Reference: U.S. Oil Sands (USOS) PR Spring Mine Response to Initial Review – List of Pages

Re: **M/047/0090 - U.S. Oil Sands, Inc., PR Spring Mine – Response to Initial Review of Revised Notice of Intention (NOI) to Commence Large Mining Operations**

**Response to INITIAL REVIEW OF NOTICE OF INTENTION
TO COMMENCE LARGE MINING OPERATIONS**

**U.S. Oil Sands
PR Spring Mine**

Title
Cross Sections 1 - 3

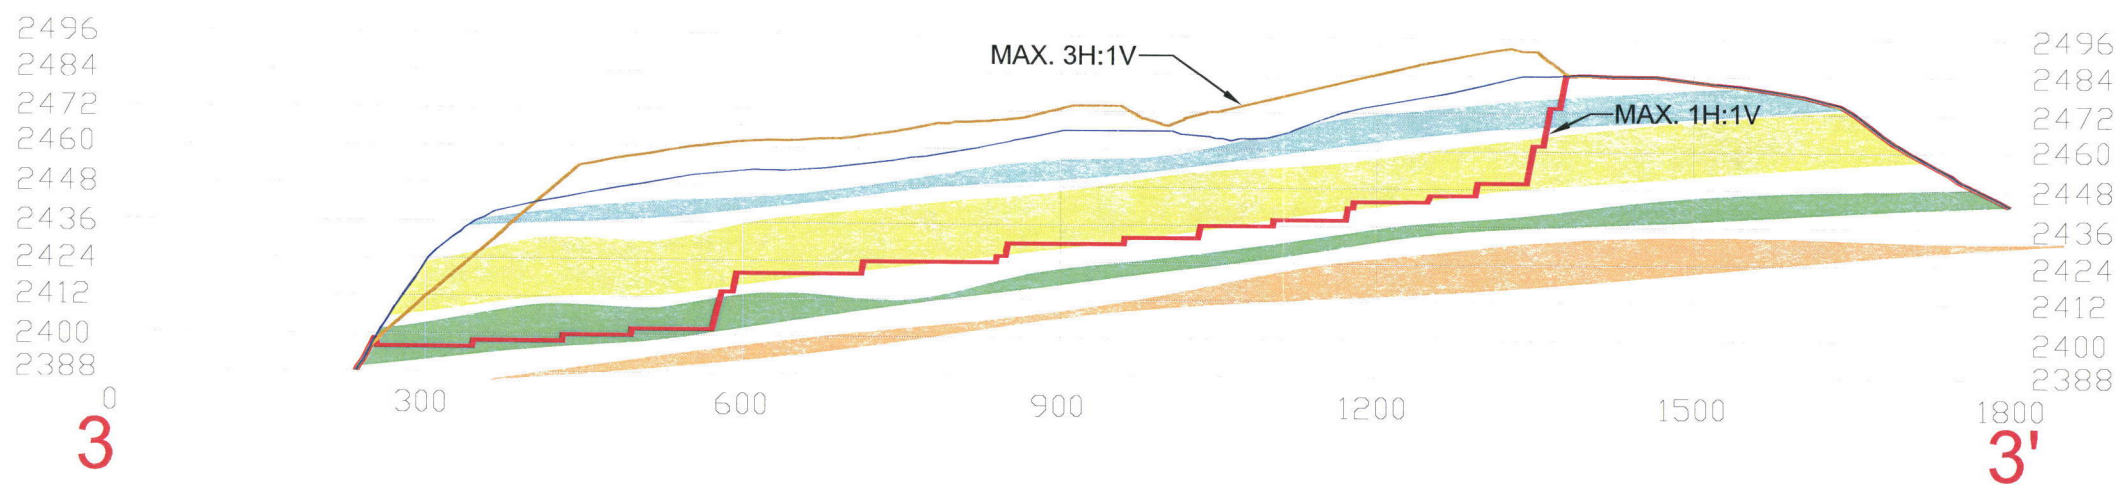
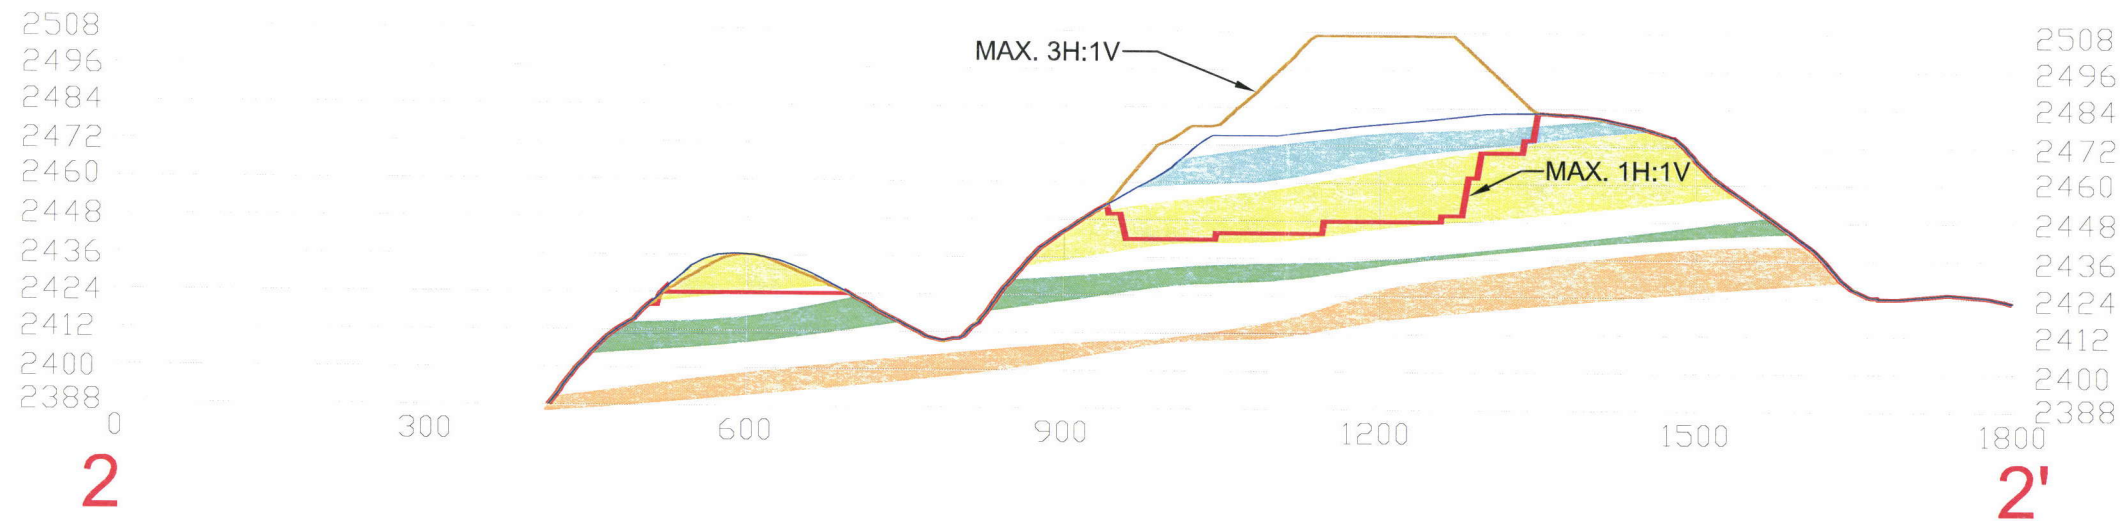
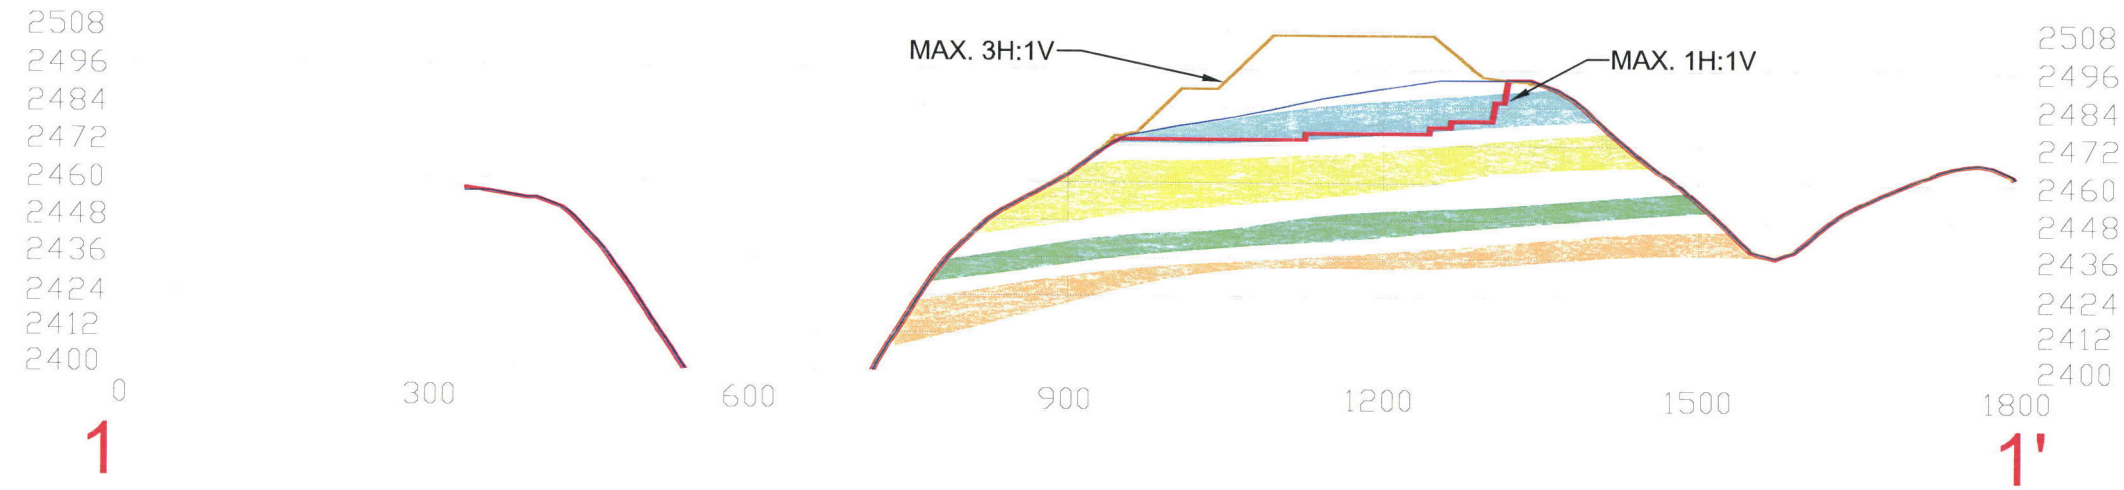
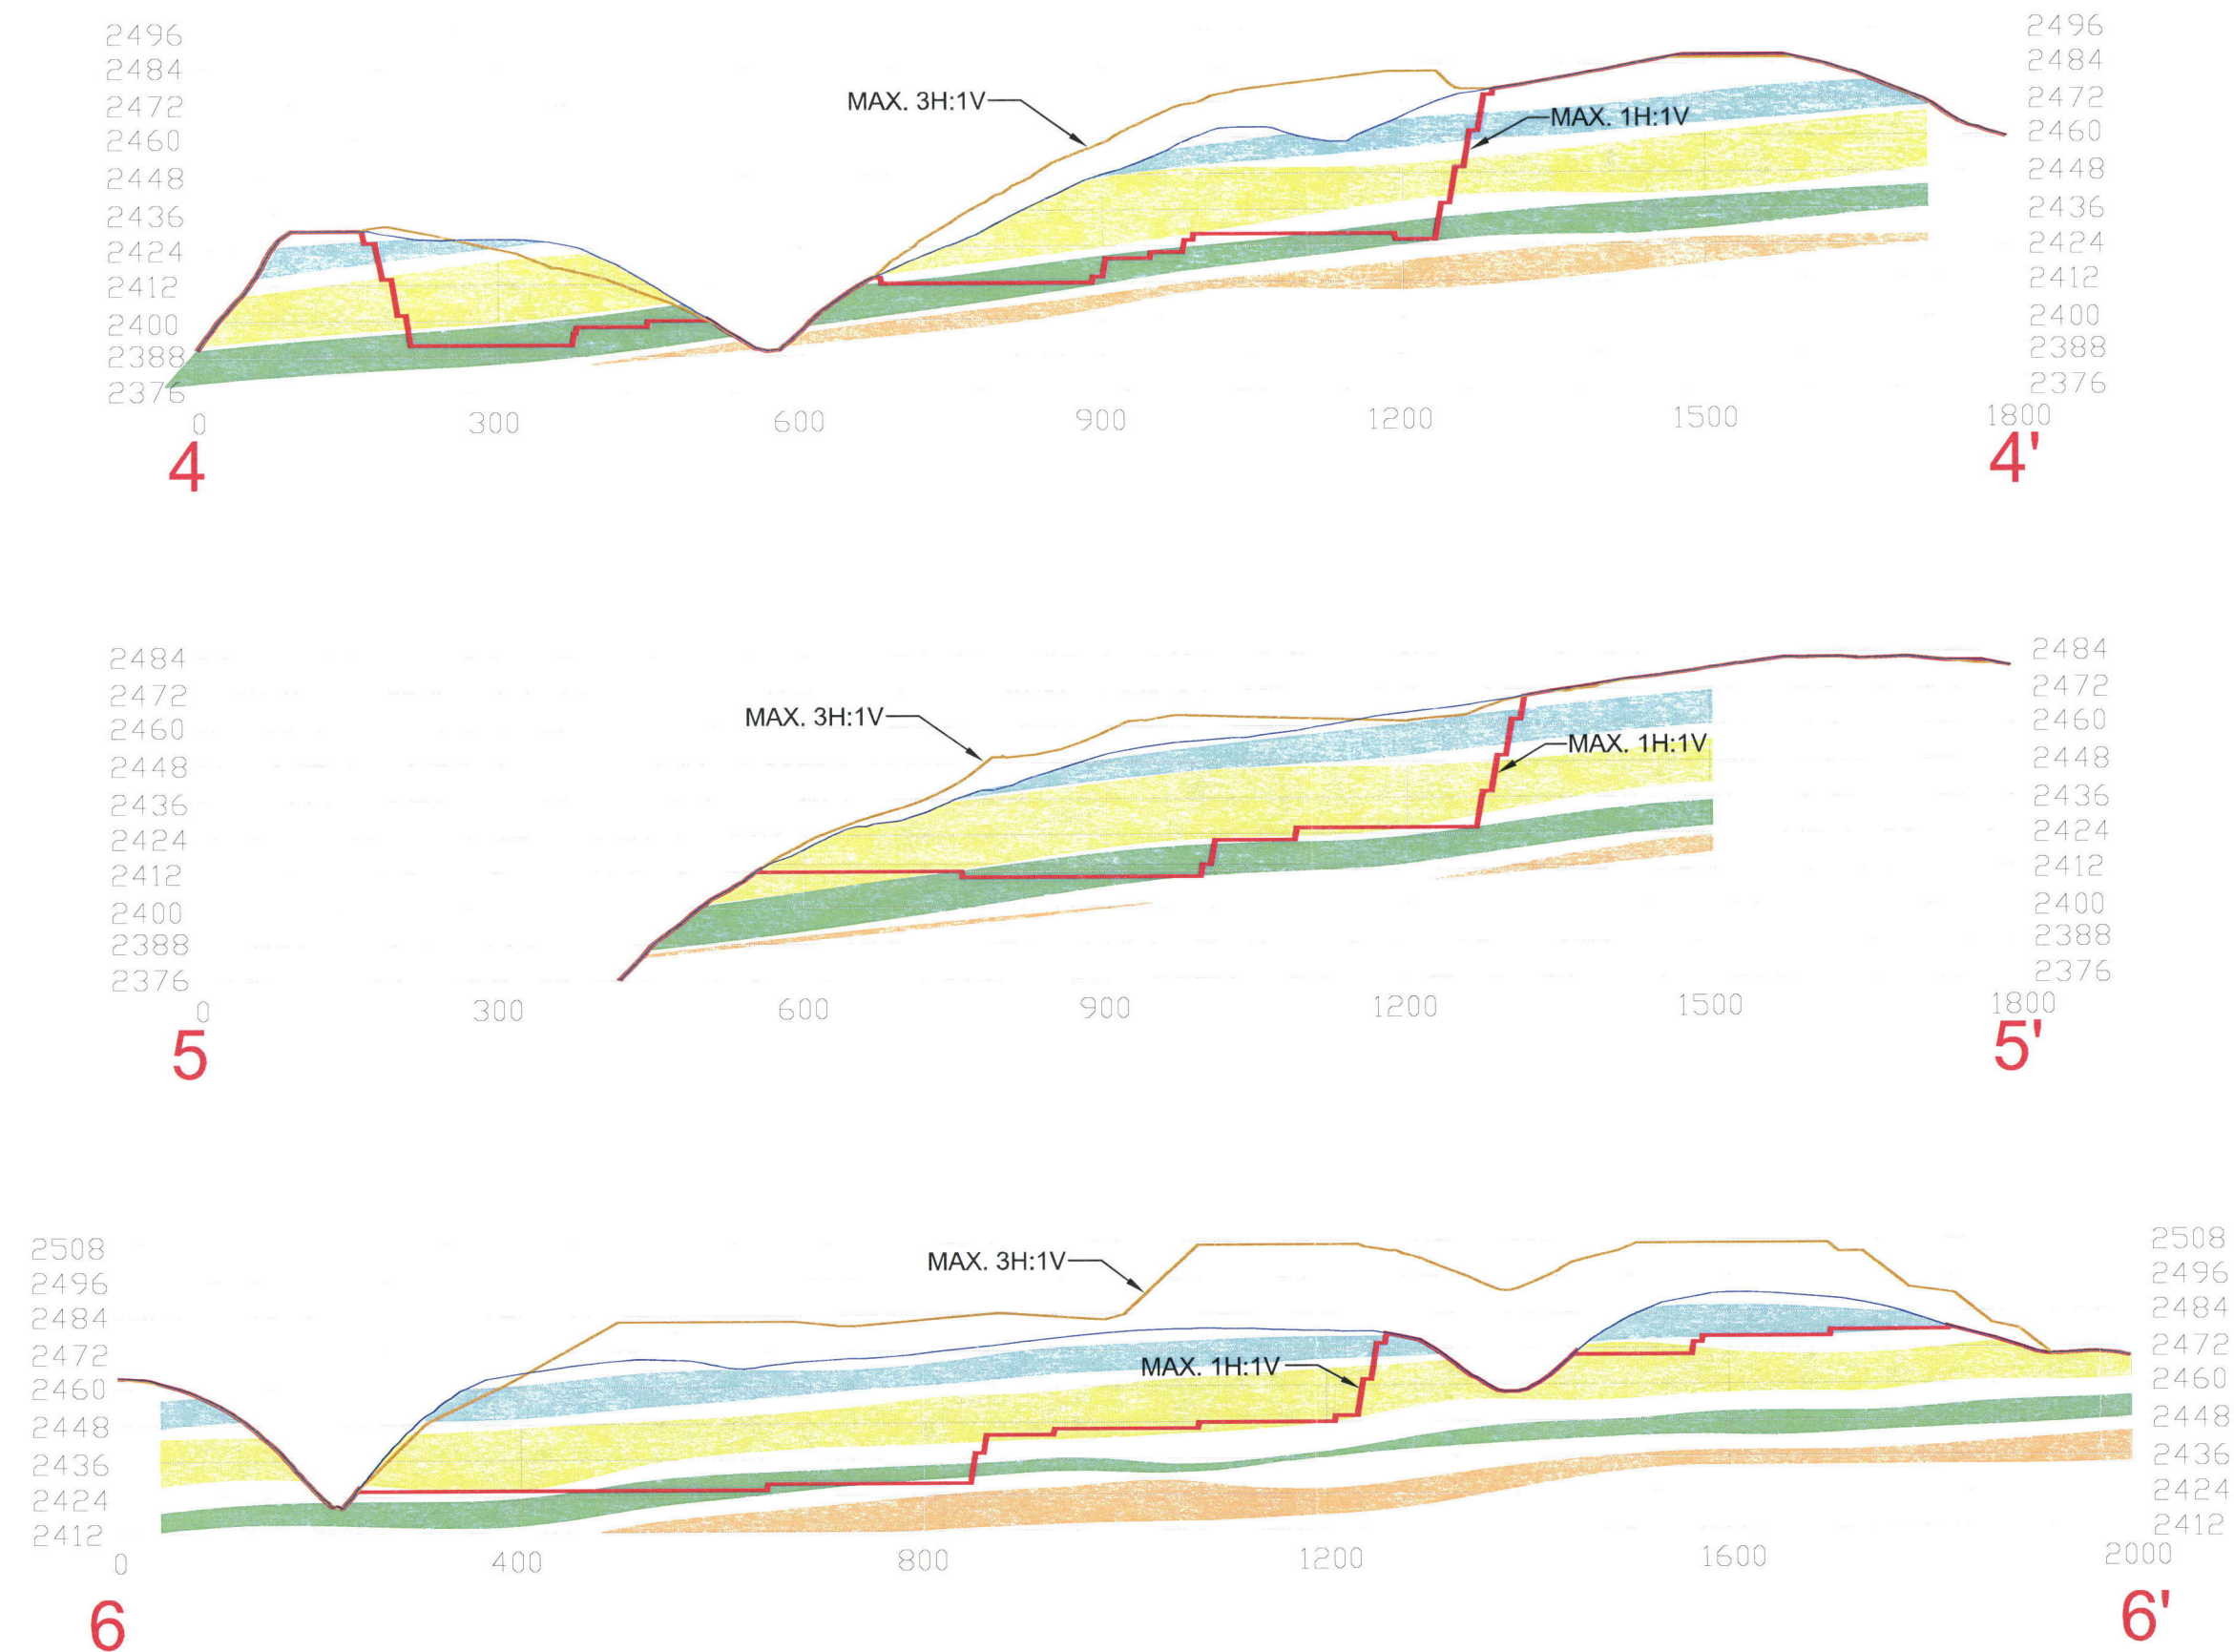
Com ment #	Sheet/Page/ Map/Table #	Comments	Initia ls	Revie w Actio n
6	All X-sections	On Figures 6a, 6b and 6c, please label the slope angles on both the cut and the fill slopes to be consistent with the text. The rock slopes discussed on page 10 commit to 1H:1V slope, so please label x-sections as “max 1H:1V”. Fill slopes noted on page 15 to be no steeper than 3H:1V, so please label x-sections as “max 3H:1V”. <i>On Figures 6a and 6b, the slope angles have been labeled as suggested.</i>	lah	
7	Omission	Please add a figure or plan sheet of “typical BMP’s” for erosion control. The BMP design drawings from the original Notice were omitted for this submission. The Division would like to have the BMP erosion control structures resubmitted so these structures match the ones that will be used onsite. <i>BMP drawings are being provided in Appendix G. Also see comment #12</i>	lah aa

Reclamation Plan

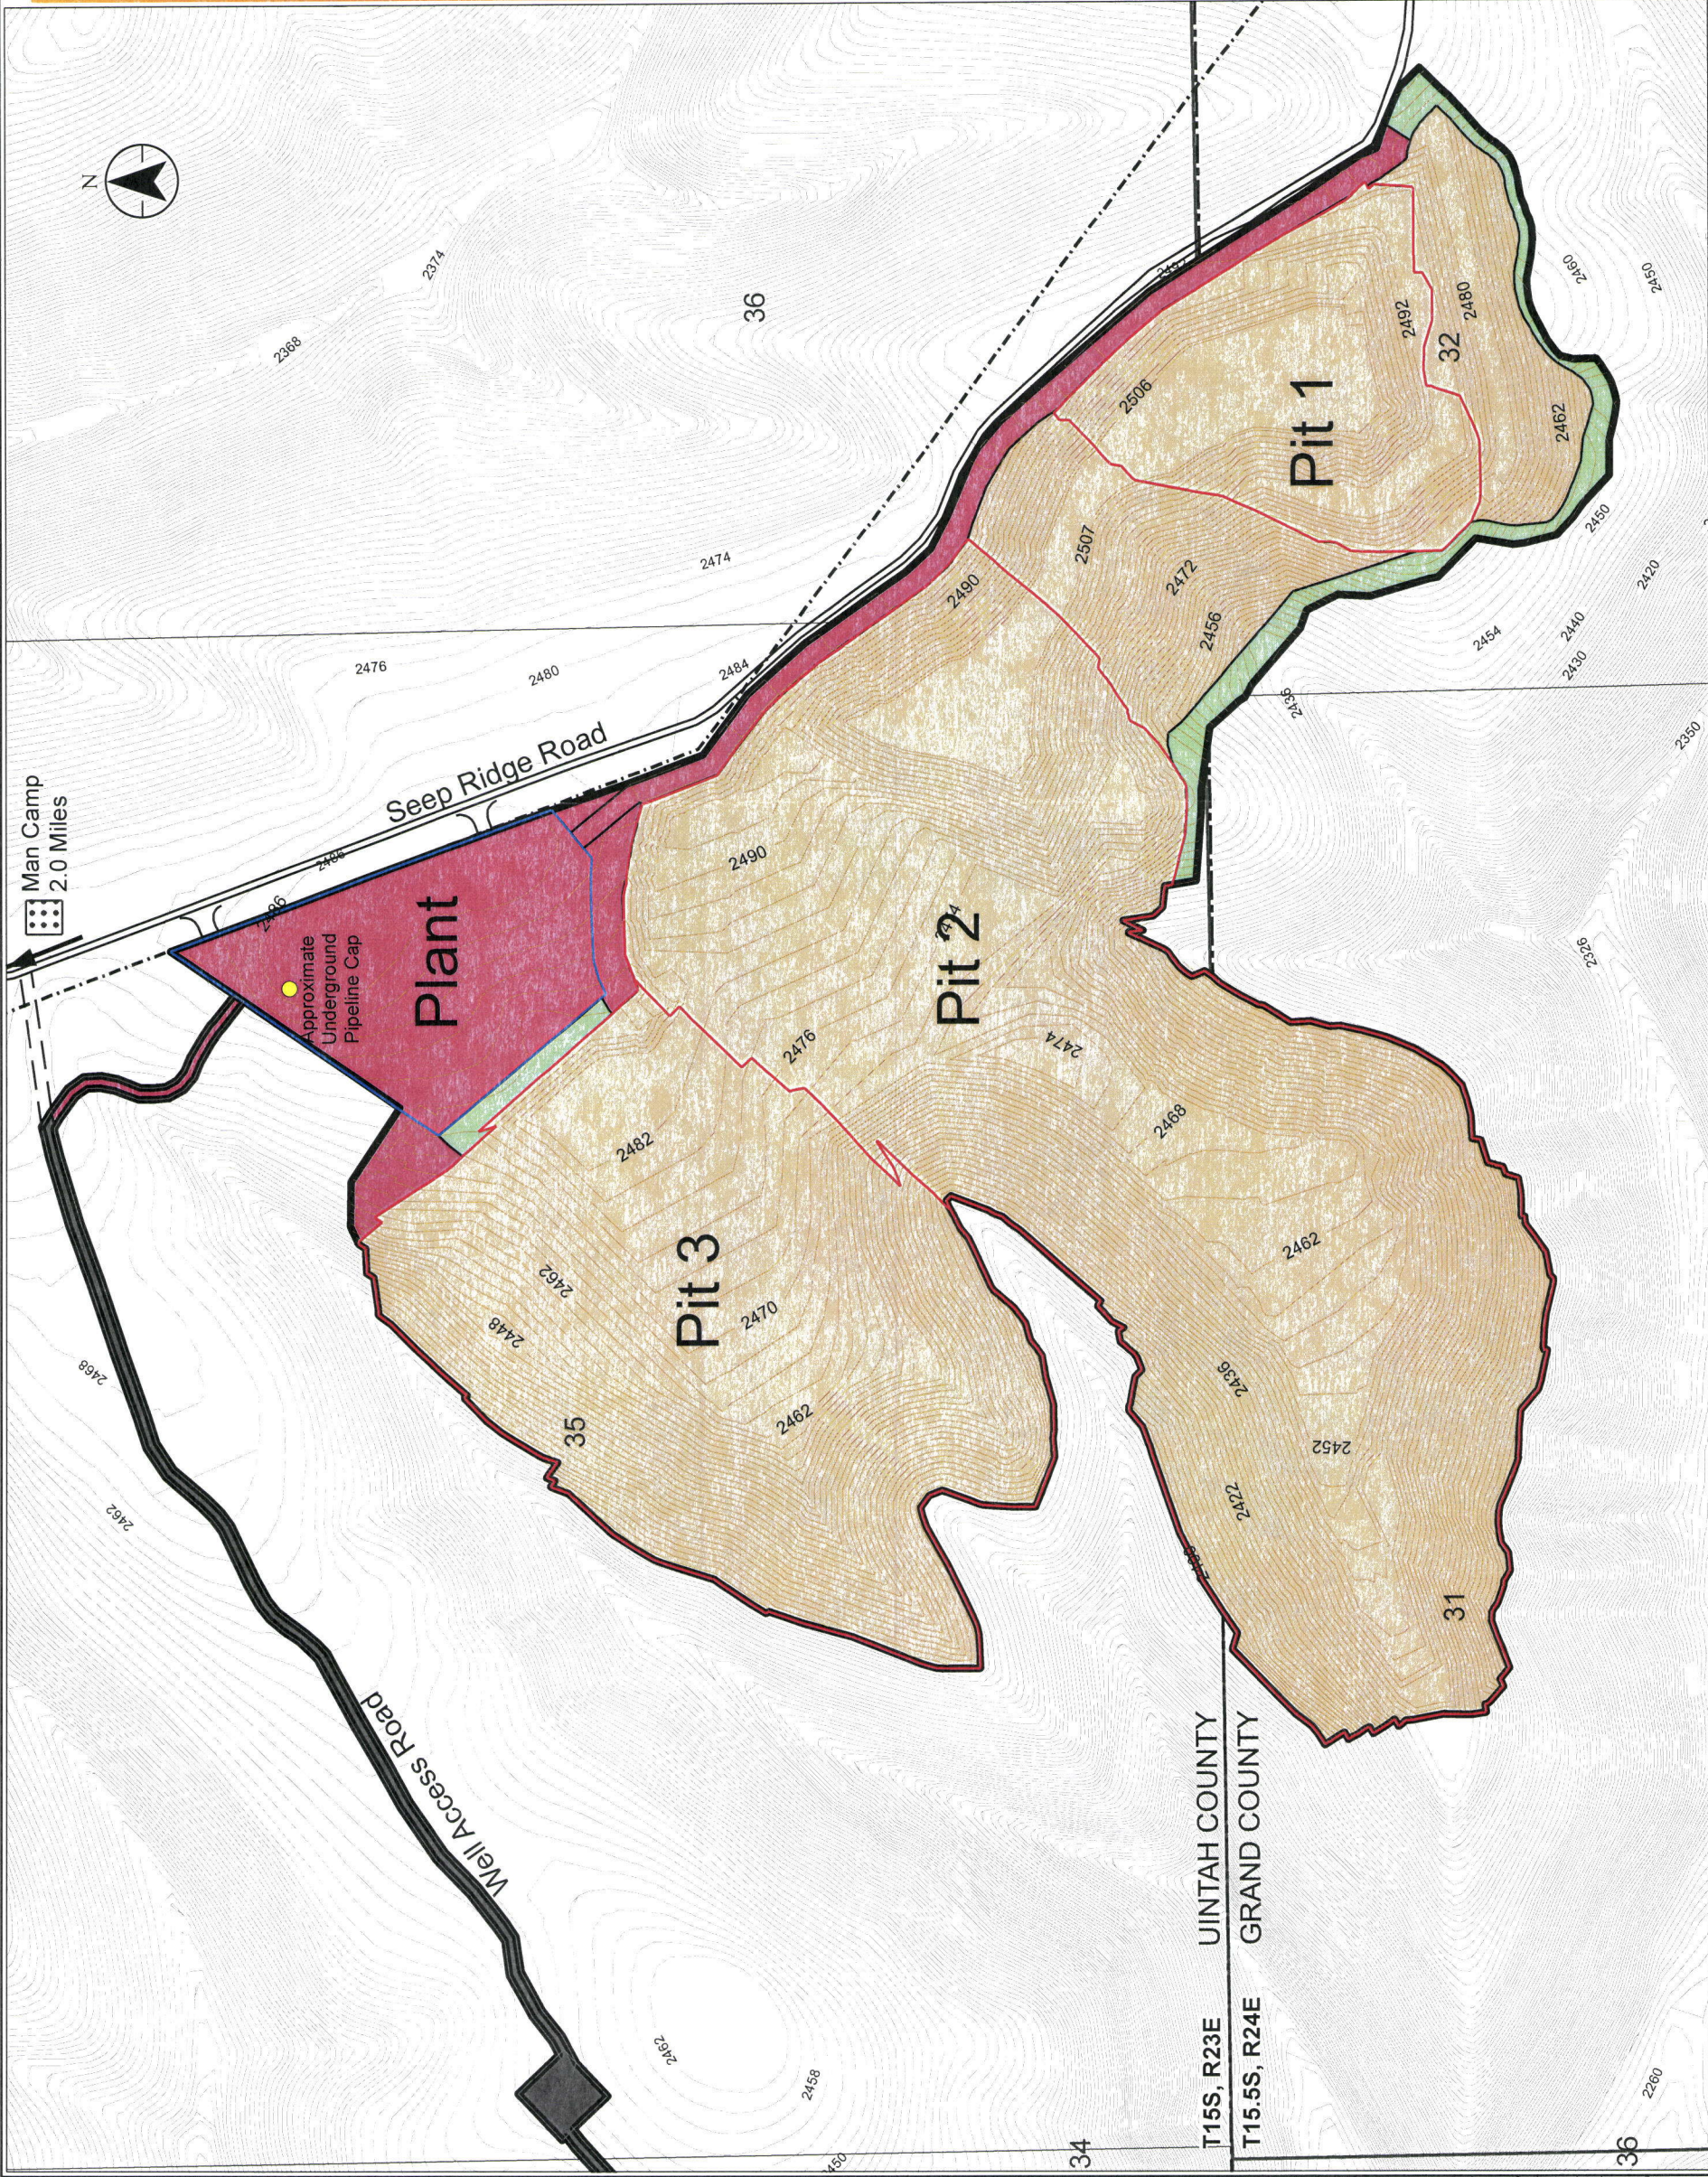
14	Figure 11	The legend shows the man camp in the same color disturbance area on the inset map. The man camp should be labeled as being off the map and include an arrow with a note showing the distance. The suggested changes have been made on Figure 11.	lah	
15	Figure 11	Please include the placement of interim reclamation erosion control features on this map (see comment 38). Figure 7 indicates interim reclamation erosion control features to be used as disturbance progresses through the mine plan. Figure 11 shows final reclamation contours at end of year 5 and reclamation treatments. All erosion control BMPs will be utilized during concurrent reclamation as well as the time from seeding up through the time when vegetation is successful.	aa
